**BELLEVILLE COMBINED LICENSE APPLICATION – RESPONSE TO REQUEST FOR
ADDITIONAL INFORMATION – STABILITY OF SUBSURFACE MATERIALS AND
FOUNDATIONS**

Reference: Letter from Ravindra G. Joshi (NRC) to Andrea L. Sturgis (TVA), Request for
Additional Information Letter No. 101 Related to SRP Section 2.5.4 for the
Belleville Units 3 and 4 Combined License Application, dated August 5, 2008

Responses to NRC Request for Additional Information letter No. 101 dated August 5, 2008
(51 pages, including this list)

Subject: Stability of Subsurface Materials and Foundations as detailed in the Final Safety Analysis Report

Figure 1

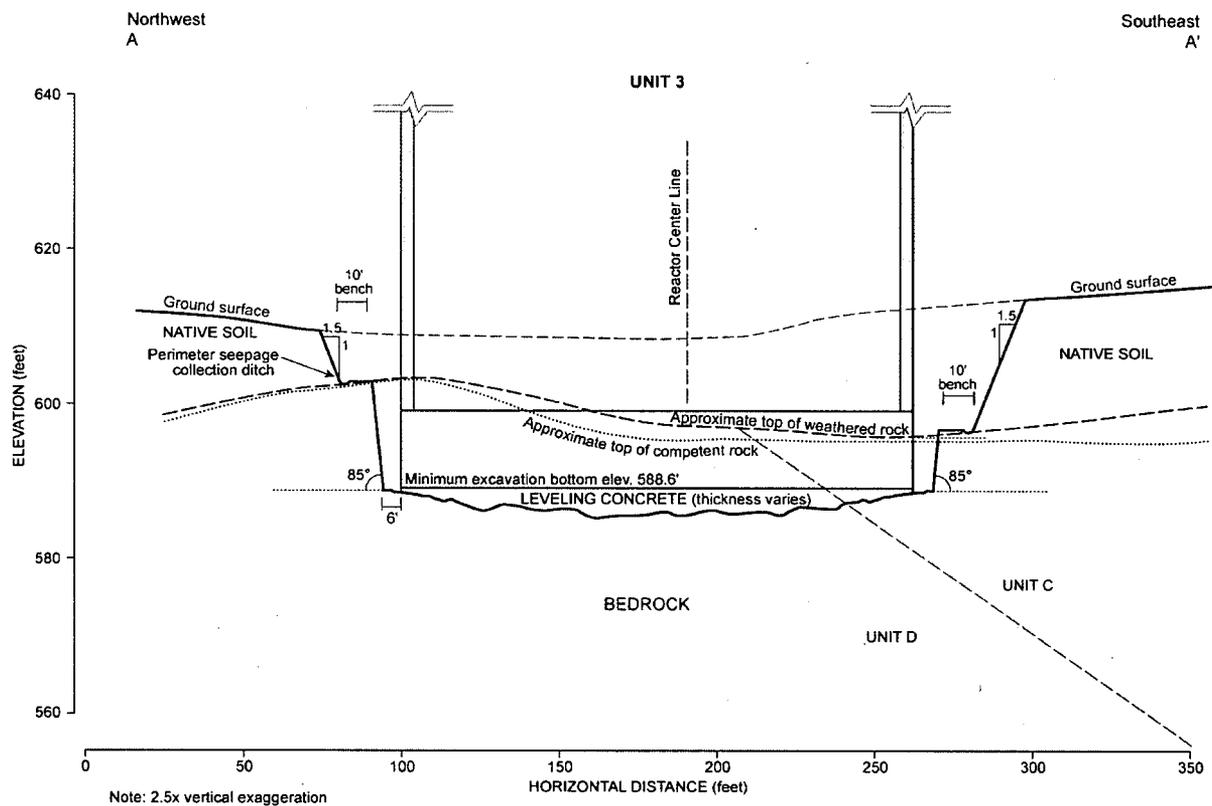
The Unit 3 foundation will consist of a relatively thin (1 to 5 ft) layer of leveling concrete emplaced on rock Units C and D (See Figure 1 of Attachment 02.05.04-05A). The leveling concrete will have a shear wave velocity comparable to the lower velocity Unit C which is less than the shear-wave velocity of Unit D.

The Unit 3 foundation velocity structure produced by the dipping strata and the layer of fill concrete consists of two distinct velocities, Unit D with a shear-wave velocity of 10,000 fps, denoted V2, and Unit C and the fill concrete, both with a shear-wave velocity of 6500 fps, denoted V1. This value for V1 is selected to correspond to the lowest plausible mean estimate of V1 consistent with Figure 2 shown in Attachment 02.05.04-05A to obtain the most conservative estimate of the potential influence of V1 on site response and potential seismic force concentrations. These distinct shear-wave velocity regions always have the lower velocity material, V1, located above the higher velocity material, V2. Separating the two velocity units is a nearly flat interface between Unit D and the fill concrete under the western portion of the Unit 3 foundation and a 15 degree east-dipping interface between Units C and D beneath the eastern part of the Unit 3 foundation (shown in Figure 1 of Attachment 02.05.04-05A).

The maximum combined thickness of Unit C and the fill concrete between the basemat and Unit D at the eastern limit of the basemat is about $h=12$ ft. (see Figure 1 of Attachment 02.05.04-05A). The minimum resonance frequency associated with amplification occurs at the eastern limit of the basemat corresponding to the maximum value of h . The minimum resonance frequency associated with amplification is $f=V1/(4*h)=135$ Hz, using the quarter wavelength approximation (Boore and Brown, 1998; eqns. 2 and 5)(Reference 1). Consequently, any amplification associated with the lower-velocity Unit C portion of the basemat will occur at frequencies greater than 100 Hz, which exceeds the maximum frequency considered in probabilistic seismic hazard analyses (NRC Regulatory Guide 1.208, Page 7, last paragraph).

Figure 2

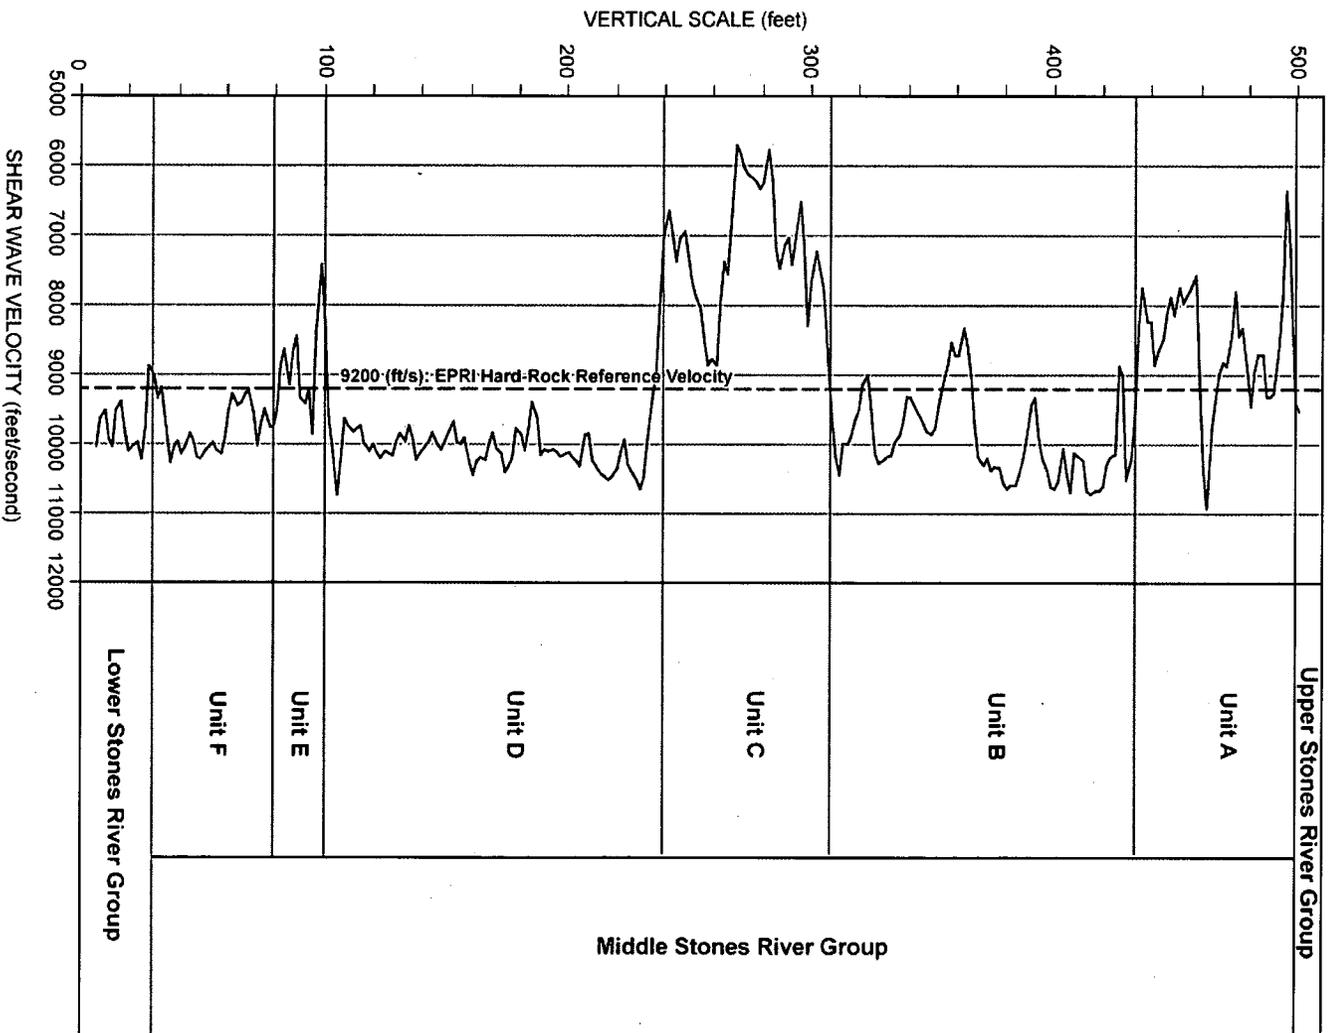
AP1000 DCD (Rev.16) has site criteria for the lateral variability of the foundation supporting soils. Geologic units inside the Middle Stones River Formation demonstrate different geotechnical properties. For example, FSAR Figure 2.5-299 shows a sharp contrast between Units C and D in terms of their shear wave velocities. Due to the inclining layering at the site, different geologic units will appear beneath the same reactor foundation. For example, Middle Stones River Unit C will support the eastern part of the Unit 3 foundation and Unit D will support the western half of the foundation. Please explain if this subsurface lateral variability meets the minimum requirement of the AP 1000 DCD site criteria on lateral variability. Furthermore, please explain if the inclined geologic boundaries beneath the foundation basemat will affect the surface ground motion estimates and possibly introduce a seismic force concentration.

Figure 3

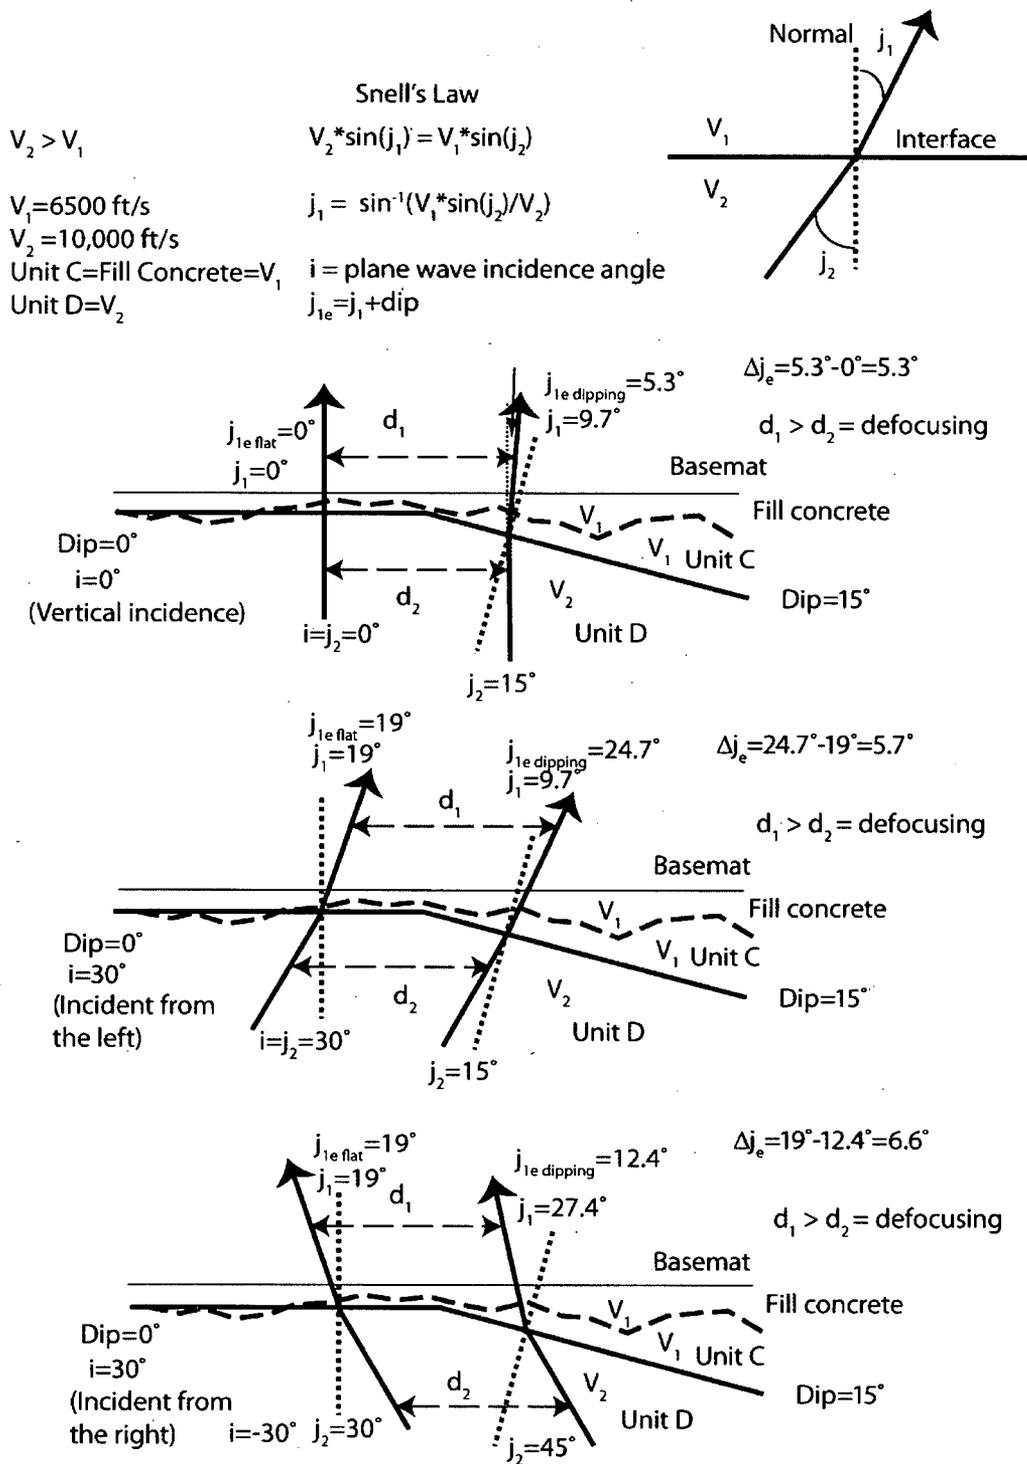
The second part of the question asks if inclined geologic boundaries beneath the foundation basemat will affect the surface ground motion estimates and possibly introduce a seismic force concentration. To answer this question, the potential for surface ground motion amplification associated with lower-velocity Unit C and the fill concrete is first evaluated and then the possibility of a force concentration associated with the inclined geologic boundaries beneath the foundation basemat is evaluated.

The velocity structure beneath Unit 3 approximates a plano-concave lens that diverges collimated incident waves, in this case incident SH-waves. The qualitative effect of the dipping strata beneath Unit 3 is to defocus seismic forces in the foundation basemat where the dipping interface intersects the fill concrete. The velocity structure does not produce a convergence (focusing) of seismic forces in any other portion of the foundation. Snell's law is used to demonstrate that ray divergence in the fill concrete and Unit C near the intersection of the dipping interface with the fill concrete is never less than 5.3 degrees for the angles of incidence associated with incident shear waves (Figures 3 and 4 of Attachment 02.05.04-05A). The only systematic influence of the dipping strata beneath Unit 3 is to locally decrease seismic forces in the

Revised Figure 2.5-314, Rev. 1
Elevation Contour Maps of Top of Competent Rock from Borehole Data

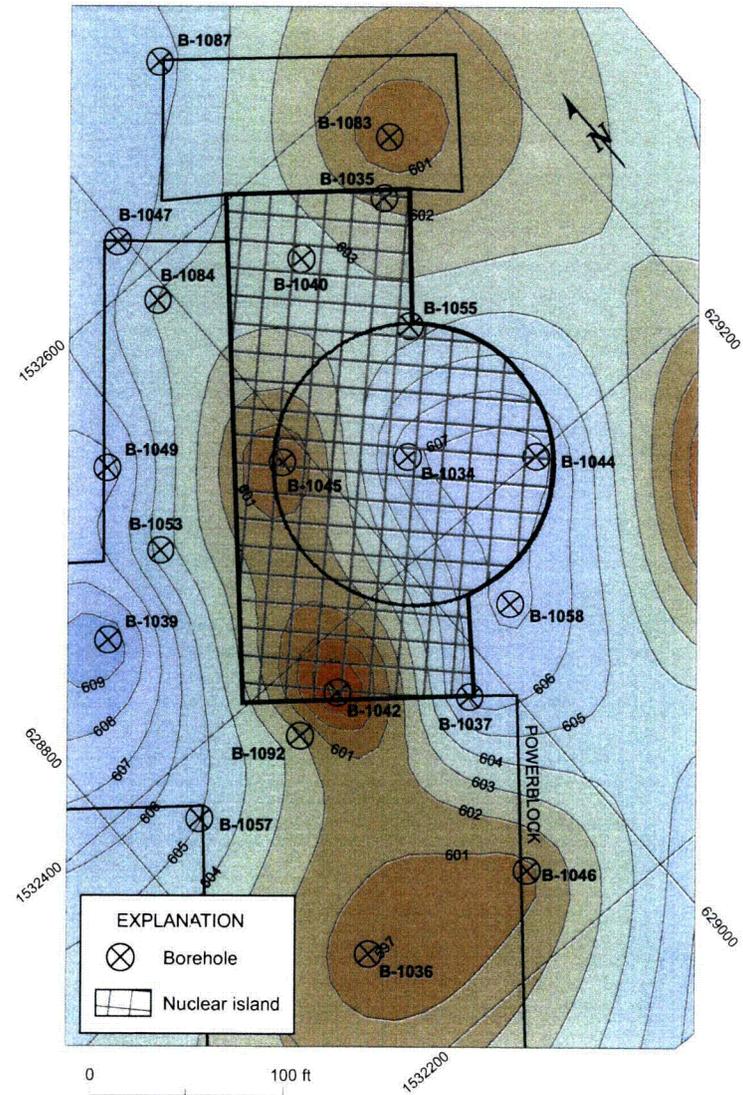
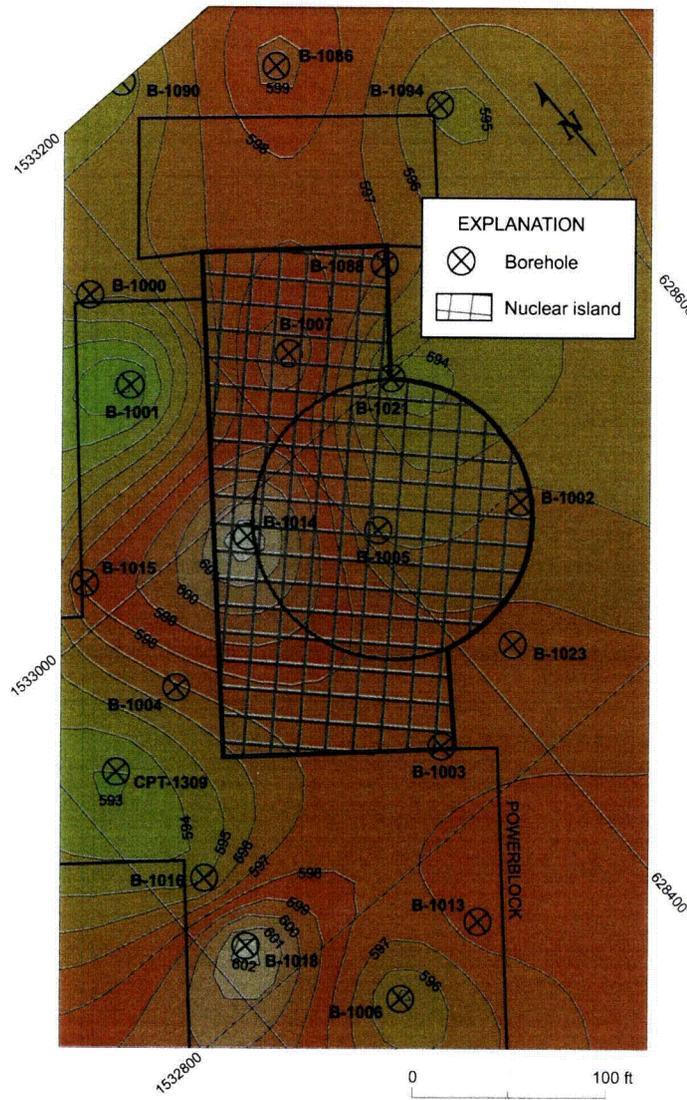
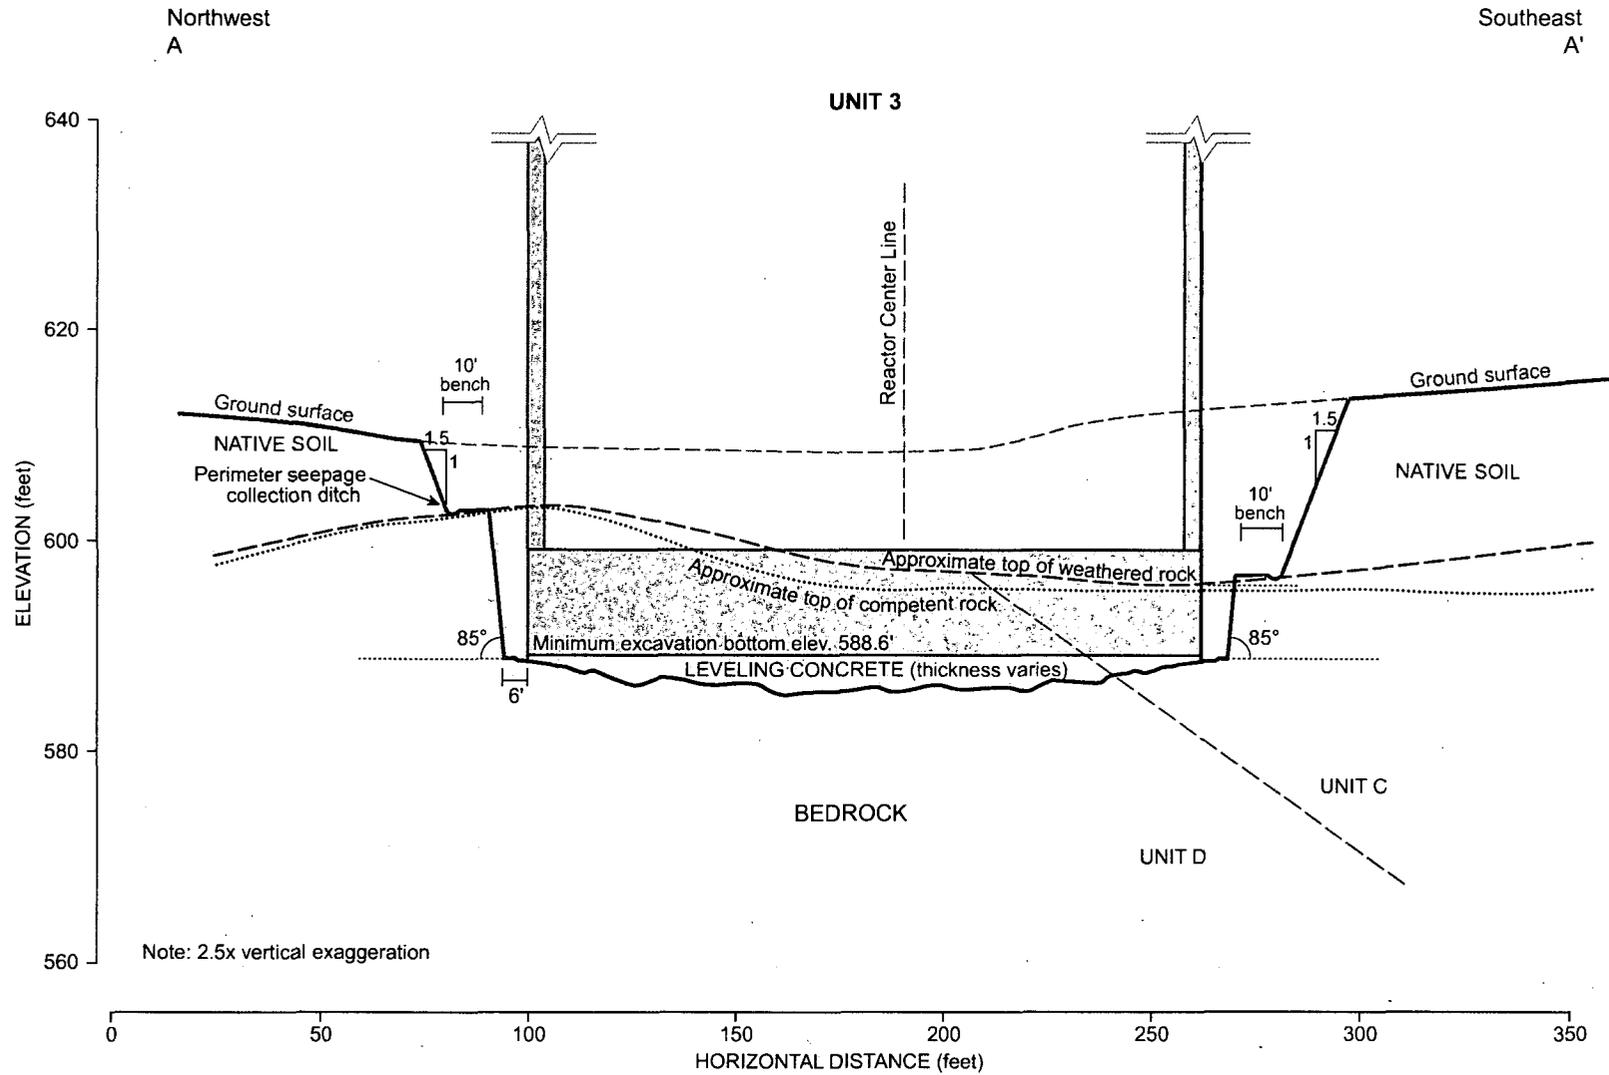
Based on seismic reflection profiles, FSAR Section 2.5.4.1.3.3 presents P-wave velocity (V_p) contours for two surfaces at 6000 and 14000 ft/sec, respectively (in FSAR Figures 2.5-312 and 313). You also implemented P-S suspension logging to measure the P wave velocity profiles at various borehole locations. Please provide a comparison of the wave velocity profiles obtained from these two different methods. Are these methods consistent in terms of P wave velocity measurements? FSAR Figure 2.5-339 shows a site stratigraphic profile across the site, including borehole locations and corresponding shear wave velocity profiles, as well as Units 3 and 4 foundation profiles. The figure demonstrates that the Unit 3 foundation excavation is located inside the bedrock with a shear wave velocity about 9000 fps and a P wave velocity of about 16000 fps. FSAR Figure 2.5-314, however, shows a large area underneath Unit 3 where the top of the 14000 fps (V_p) layer is below elevation 588.6 ft. Please explain the discrepancy.

The discrepancy between estimates to top of competent rock defined by the depth to a P-wave velocity of 14,000 fps based on seismic refraction measurements in FSAR Figure 2.5-314 and the estimates of depth to top of competent rock defined in FSAR Figure 2.5-339 based on borehole data are the results of several systematic factors in the acquisition, analysis, and interpretation of the seismic refraction data that tend to introduce a bias to overestimate refractor depths.

The cumulative effects of all refractor depth estimation biases is sufficient to explain the tendency of Figure 2.5-314, based on seismic refraction analyses of depth to refractor, to overestimate depths to top of rock by 0-20 ft relative to FSAR Figure 2.5-339, which is based on borehole data. Consequently, the most appropriate definition of depth to competent rock should be based on borehole data and actual conditions revealed during excavation, not on the seismic refraction data.

Contour maps of the top of competent rock for Units 3 and 4 (Figure 2.5-314), similar to the top of weathered rock (Figure 2.5-310), show an irregular surface below the soil and weathered rock overburden. Excavations are expected to extend below these irregularities such that both Units 3 and 4 nuclear islands will be founded entirely on competent rock. Foundation grade is 588.6 feet for both units. However, local deep depressions in the bedrock surface, not discovered by the existing borehole grid, may be present that would require additional localized excavation.

4. COLA Part 2, FSAR Chapter 2, Figure 2.5-314 will be revised as presented in Attachment 02.05.04-06A.

FIGURE 2.5-348a
Vertical Limits of Excavation, Unit 3

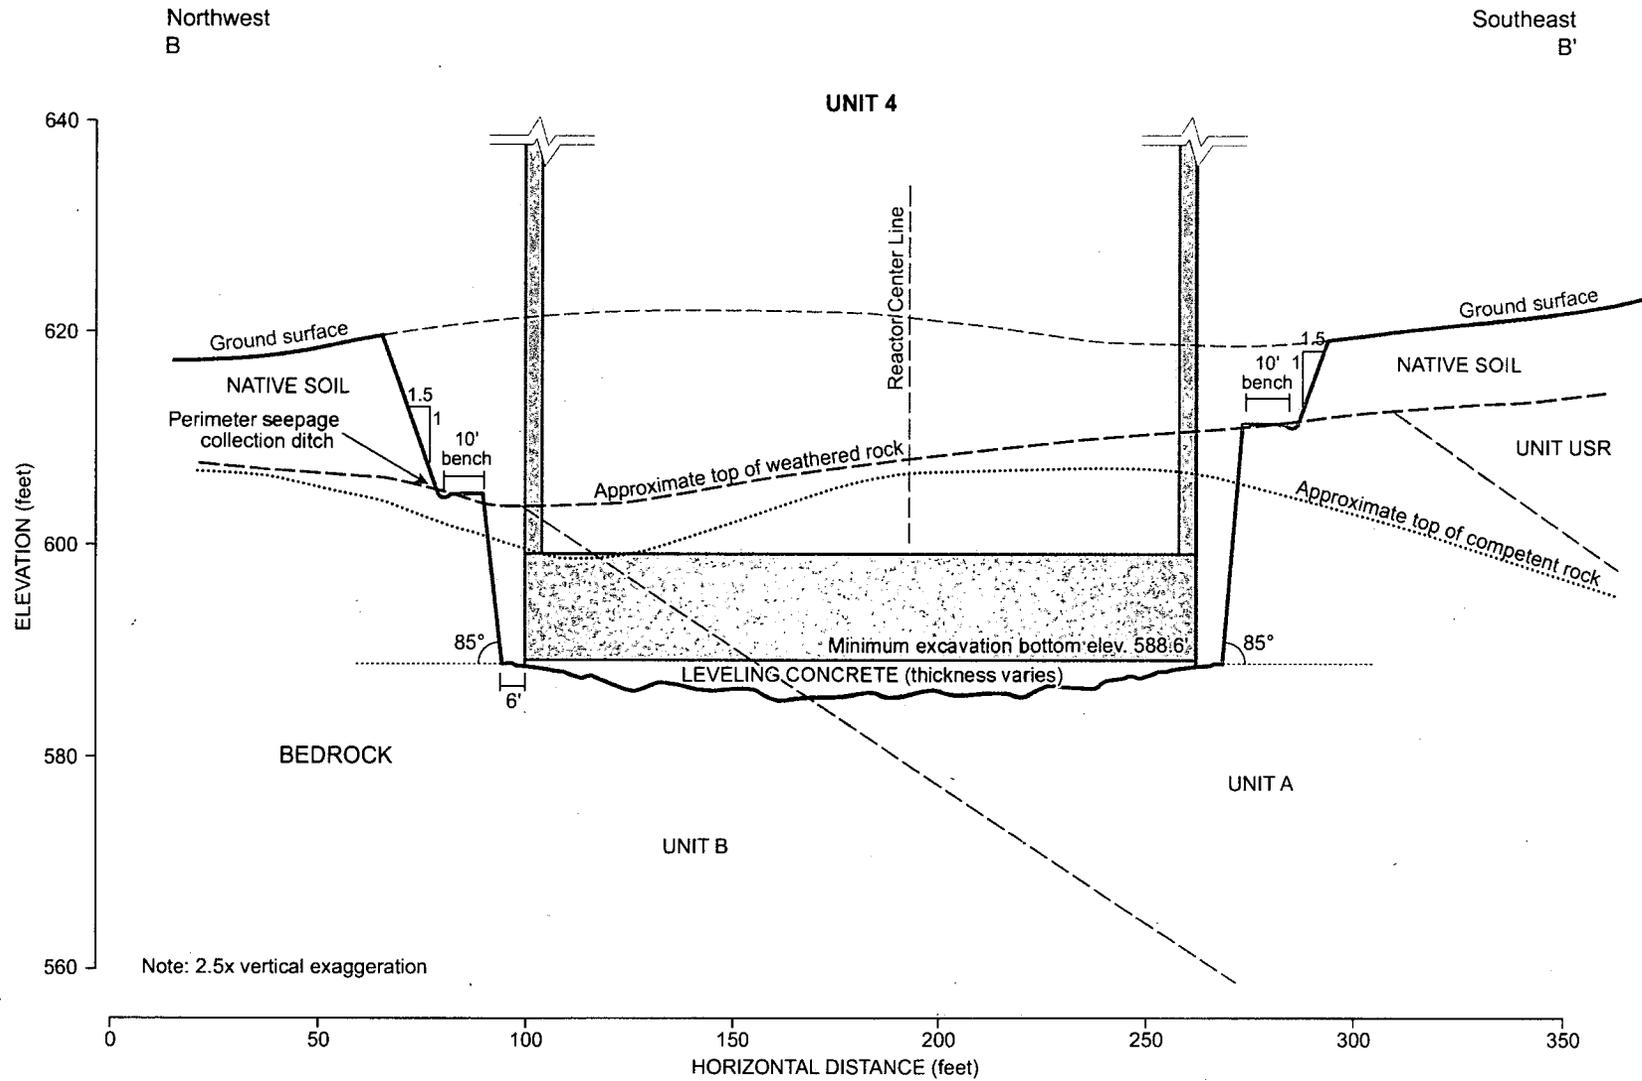
...The soil excavation is sloped at a 1.5 (Horizontal): 1 (Vertical) inclination, as illustrated in Figures 2.5-348a and 2.5-348b, so lateral support is not required. Analyses of the slope temporary soil slopes show factors of safety greater than 2.0.

5. COLA Part 2, FSAR Chapter 2, Figure 2.5-348a will be revised as presented in Attachment 02.05.04-06A.

COLA Part 2, FSAR Chapter 2, Figures 2.5-348a and 2.5-348b will be revised as part of the response to NRC RAI No. 02.05.04-06.
